Re: FortisBC Energy Inc. (FEI)

Application for a Certificate of Public Convenience and Necessity (CPCN) for Approval of the Advanced Metering Infrastructure (AMI) Project (Application)

Response to the British Columbia Utilities Commission (BCUC) Information Request (IR) No. 1

Figure 1-1: Project Logical Architecture

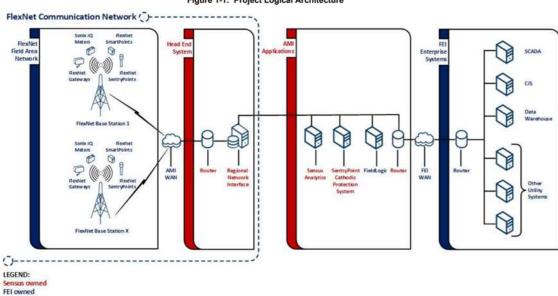
Figure 5.1, on page 77 of the Application, provides a depiction of the Project Logical Architecture. In Attachment 2 of Exhibit B-2, FEI provides a higher resolution version of the same figure, which is reproduced below.
